## Annex 3 - Proposed Grid Code Legal Text

### DRAFT REACTIVE CAPABILITY / VOLTAGE CONTROL LEGAL TEXT

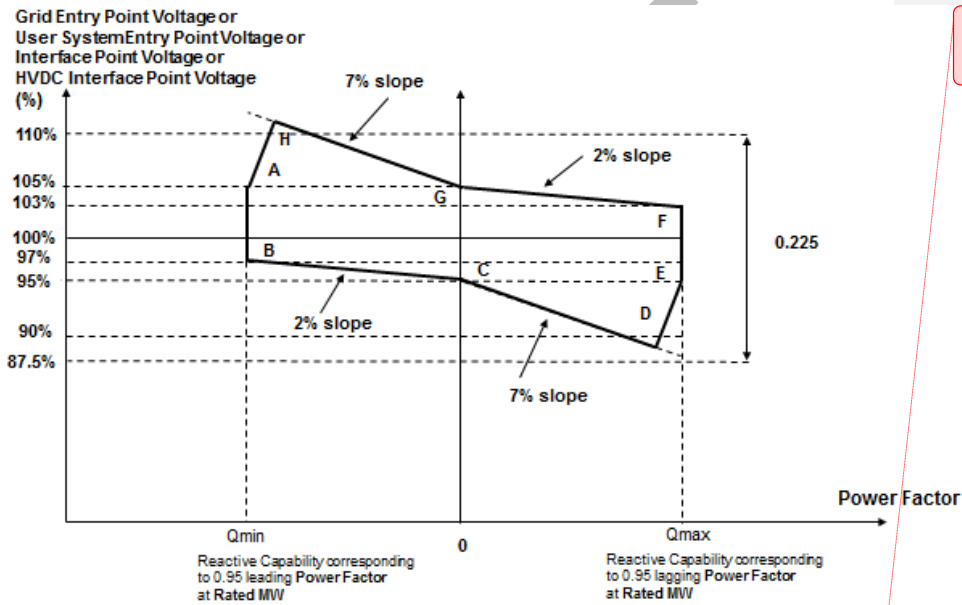
**Comment [NG27]:** This diagram needs updating to include HVDC Interface Point Voltage

**Figure ECC.A.7.2.2b**

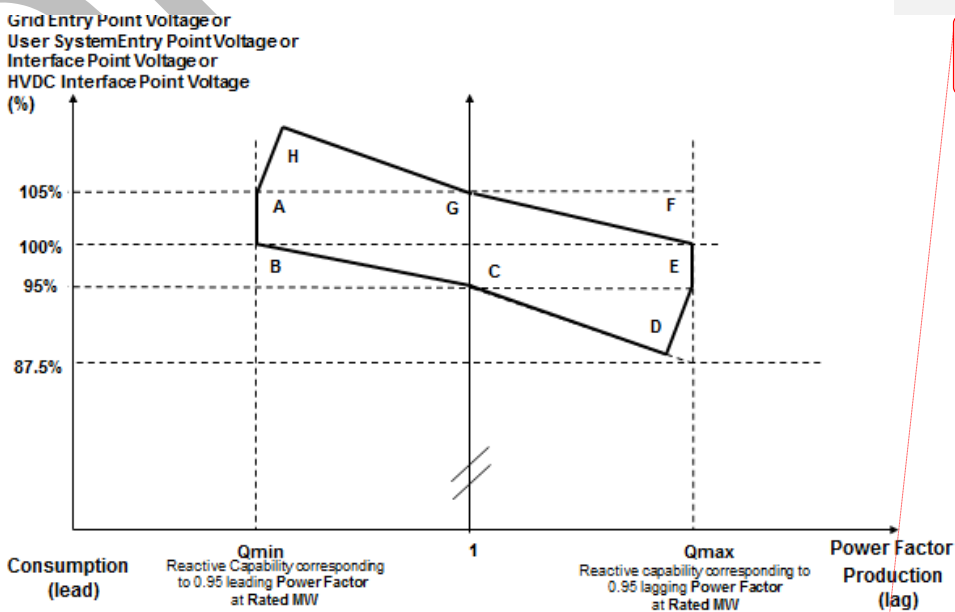
**Comment [NG28]:** This diagram needs updating to include interface Point and HVDC Interface Point Voltage

### HV Generator Performance Chart

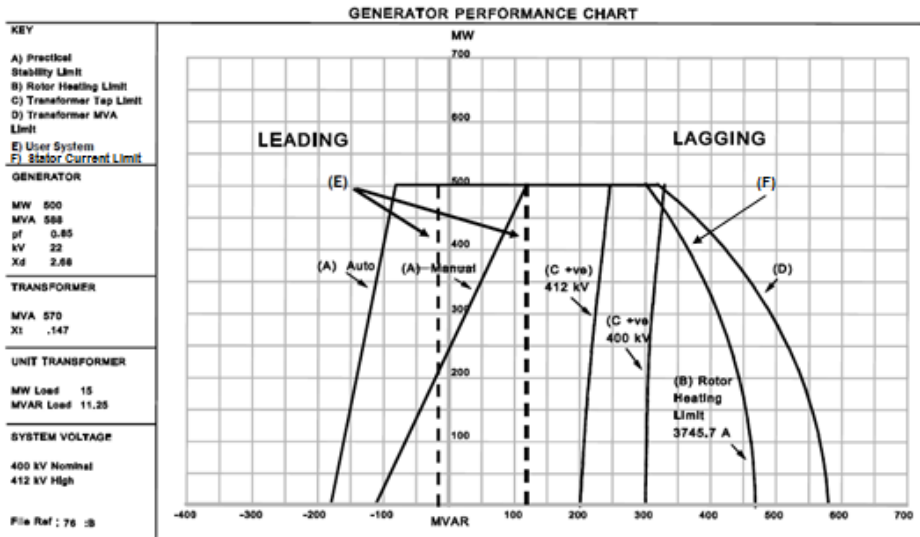
Comment [NG32]: Diagram to be updated to provide an HV Synchronous Generator performance chart

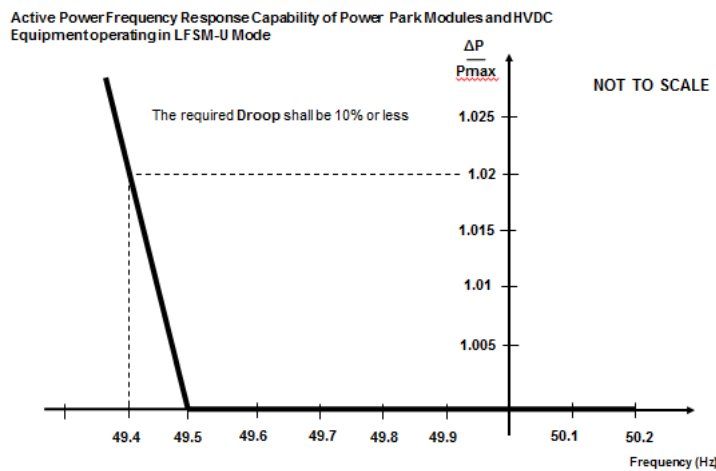
Comment [NG24]: This diagram will need to be updated in respect of DC Converters

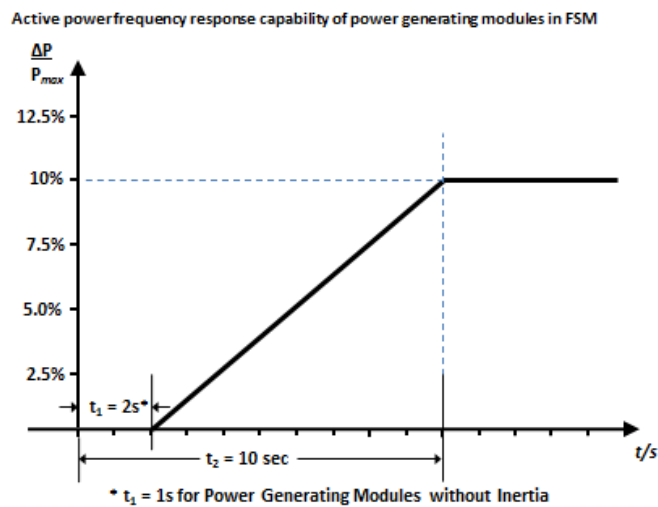
**Comment [NG28]:** This could be simplified with just the parameters inserted and references to  $t_1$  and  $t_2$  removed.

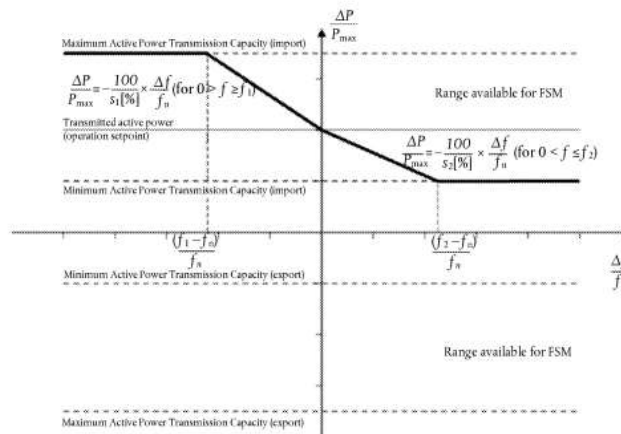
Comment [NG29]: Diagram needs to be re-drawn - with GB parameters. There needs to be a reduction in the equations
